MEMORANDUM

From:	Tina Cuss Ecology Officer		
Service	WBC Ecology	App No:	260214
Address:	Hatchgate End, Hatch Gate Lane, Cockpole Green, Wargrave, RG10 8NE.		
Proposal:	Application for submission of details to comply with the following condition of planning consent 251318 dated 08/09/2025. Condition 3. External Materials. 5. Landscaping. 6. Drainage. 7. External Lighting.		
Type of Development:			
Site Visit Made:	No

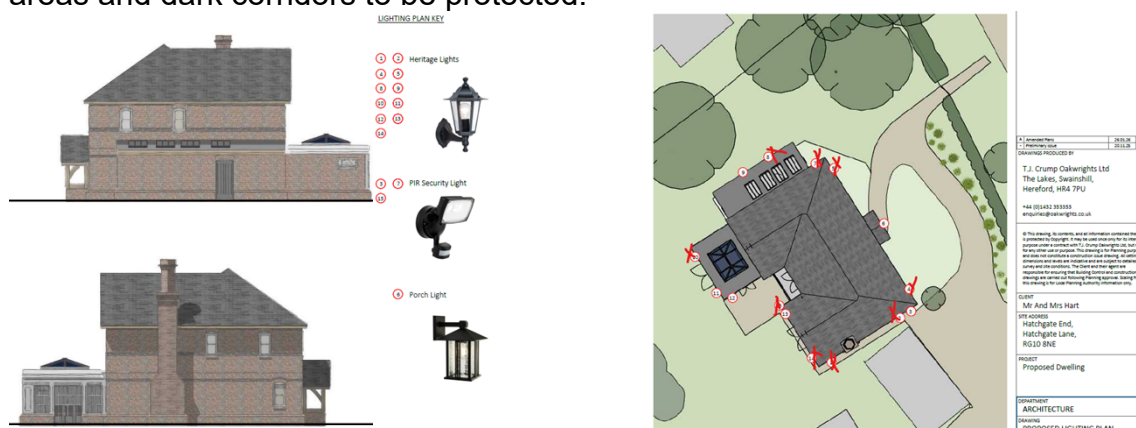
The scheme of lighting Heritage Lights and Security Lights inset images shown in the Proposed Lighting Plan Rev A are not directional angled below the horizontal,

and fail protect dark corridors, particularly along the northwestern boundary. The scheme does not justify or demonstrate the need for any external lighting on the northern and southern elevations. The lighting strategy does not identify sensitive areas and dark corridors to be protected.

- Identify areas/features sensitive for birds and bats.
- Luminaires 1,2,4,5, 10 and 14 on corners and elevations without requirement for outside access to be omitted.
- Amending Heritage Lights for downlights with limited lightspill which do not reflect upward and on to buildings or boundary foraging corridors. Detail of PIR controls.
- Omission unnecessary security light 7 and 15.
- Technical specification of luminaire 3 to be angled directed and angled at the horizontal.
- Technical specification including lux, lightspread, temperature/wavelength of luminaires and detail PIR circuits and controls of remaining wall and low watt security light 1 5.
- Provision of lighting contour plans.

I recommend that the external lighting scheme is not approved and must be amended in accordance with best practice Bats and Artificial Lighting at Night GN08/23 and the requirements of condition 7.
